THE ROCK CHURCH SUBDIVISION

Revised for the November 17th meeting:

APPLICATION NUMBER Holdover DATE February 2, 2006

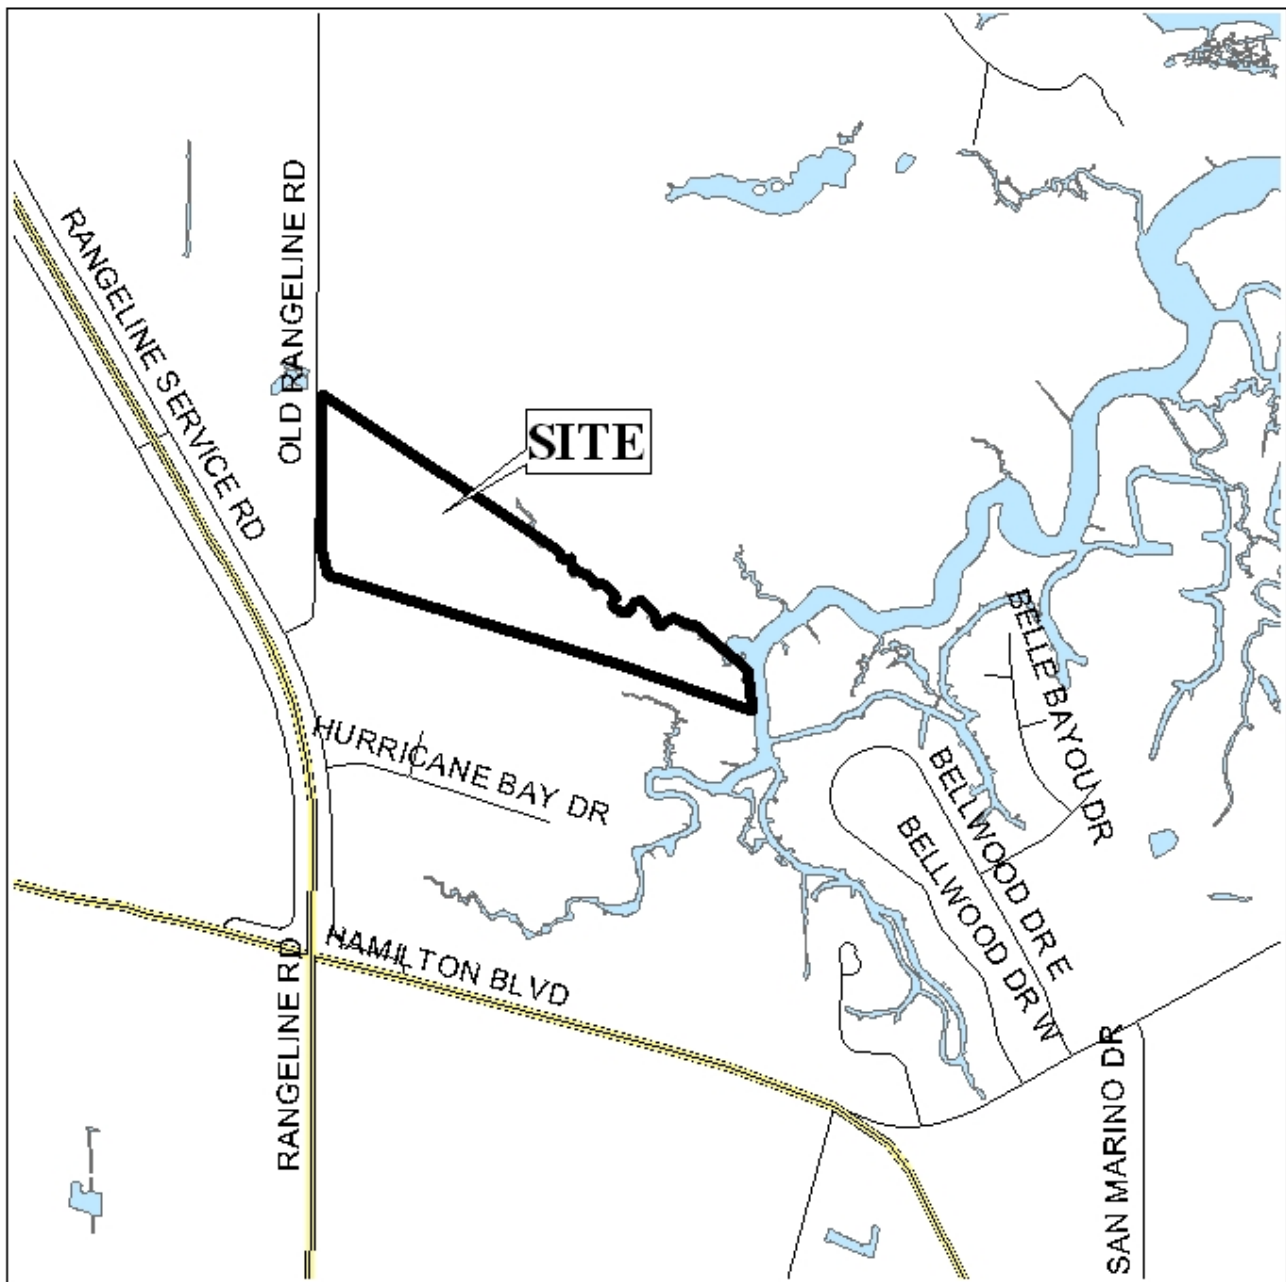
The site is located north of the intersection of Old Rangeline and Rangeline Roads. While Old Rangeline Road has an adequate right-of-way, the size of the site in question creates access management concerns. The approved subdivision in 2003 restricted the site in question to a maximum of two curb-cuts onto Old Rangeline Road; this restriction should be carried into the application currently under consideration.

Lots 1- 5 are proposed to be flag-lots with 25-foot wide strips ranging from approximately 741 feet to 1,626 feet in length, connecting them to Old Rangeline Road. If the "pole" portion of the flag-lots is excluded, all proposed lots meet the recommended depth to width ratios of Section V.D.3. Lots in the vicinity of Alligator Bayou exhibit high depth to width ratios due to the desirability of waterfront lots and the extensive wetlands in the area. Flag-lots exist along the Alligator Bayou / Dog River area, however, they create an undesirable land subdivision condition which, in this case, could easily be remedied through the provision of a public street following the existing access road on the site, or via the creation of an innovative subdivision with a private street, in conformance with Section VIII. of the Subdivision Regulations.

Based upon the preceding, the application is recommended for Denial for the following reasons: 1) the extreme flag-shaped nature of the proposed Lots 1-5 are uncharacteristic of other lots in the area, with the exception on the one adjacent flag-lot, and thus do not comply with Section V.D.1. of the Subdivision Regulations; and 2) the proposed Lots 1-5 exceed the maximum depth to width ratio identified in Section V.D.3. of the Subdivision Regulations.

The existing private road is constructed to a somewhat lesser standard than provided for in the Subdivision Regulations, but has been certified by the applicant's engineer to be in compliance with County private road standards. Therefore, a modification to VIII.E.2.c to allow the reduced standard would be appropriate. The plat as submitted indicates a 50' easement for the private road instead of the required right-of-way. The applicant's surveyor has agreed to modify the plat to comply with this requirement. The applicant's surveyor is also aware that all other requirements of VIII.E.2. will be applicable, and will be required prior to the recording of the final plat. Additionally, the placement of a note on the final plat stating that Lots 6 and 7 are denied direct access to Old Range Road should be required.

In addition to including the additional lot, the revised plat extends the private road to provide access and frontage to the additional lot.

With modification to VIII.E.2.c, the plat will meet the minimum requirements of the Subdivision Regulations and is recommended for Tentative Approval subject to the following conditions: 1) compliance with VIII.E.2., as modified by this approval (reduced construction standard) prior to the recording of the final plat; 2) the placement of a note on the final plat stating that Lots 6 and 7 are denied access to Old Rangeline and Rangeline Roads ; 3) the approval of all applicable federal, state and local agencies prior to the issuance of any permits; and 4) the placement of a note on the final plat stating that any property that is developed commercially and adjoins residentially developed property shall provide a buffer, in compliance with Section V.A.7. of the Subdivision Regulations.

With modification to VIII.E.2.c (to reduce construction standard and allow the existing construction standard as certified by the applicant's engineer), the plat will meet the minimum requirements of the Subdivision Regulations and is recommended for Tentative Approval subject to the following conditions: 1) compliance with VIII.E.2., as modified by this approval (modification to paragraph c only to reduced construction standard) prior to the recording of the final plat; 2) the placement of a note on the final plat stating that Lots 6 and 7 are denied access to Old Rangeline and Rangeline Roads ; 3) the approval of all applicable federal, state and local agencies prior to the issuance of any permits; and 4) the placement of a note on the final plat stating that any property that is developed commercially and adjoins residentially developed property shall provide a buffer, in compliance with Section V.A.7. of the Subdivision Regulations.
